Executive Summary

1) 3.1 Pollution risk and possible flood risk

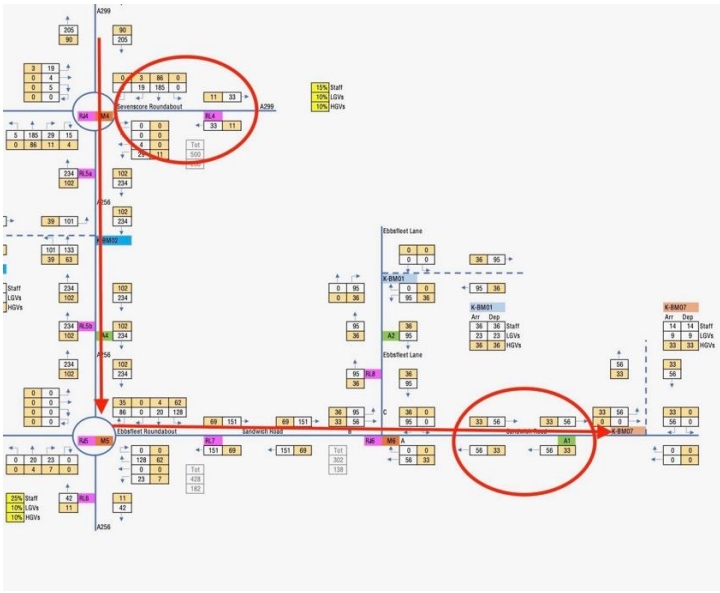
- a) In APP-181 Traffic Flow diagrams 12hr weekday (07.00-19.00) on the next page shows 90 HGVs (and 205 other vehicles) using the A253 whereas in APP-266 HGV routing map it shows HGVs using the A299 not the A253.

Is this a simple transcribing error or does the Applicant need to redo the Junction Modelling Capacity for K-RJ1?

- b) In APP-181 Traffic Flow diagrams 12hr weekday (07.00-19.00) it shows 33 HGVs continuing South at junction K-RJ4 onto the A256, left at K-RJ5 onto the Sandwich Rd, straight on at K-RJ6 until reaching K-BM07 (shown by the red arrow on both). The 33 HGVs then reverse that route from the compound at K-BM07 back to the A299.

In APP-181 Traffic Flow diagrams 12hr weekday (07.00-19.00) it shows 11 HGVs turning left at K-RJ4 (circled top left).

It is not clear to me why the 33 HGVs don't do the same onto the dual carriageway (as shown by the blue arrow on the right-hand map) and turn right at the next roundabout to reach K-BM07? This is a much shorter route, on better roads and avoids passing receptors on the Sandwich Road.
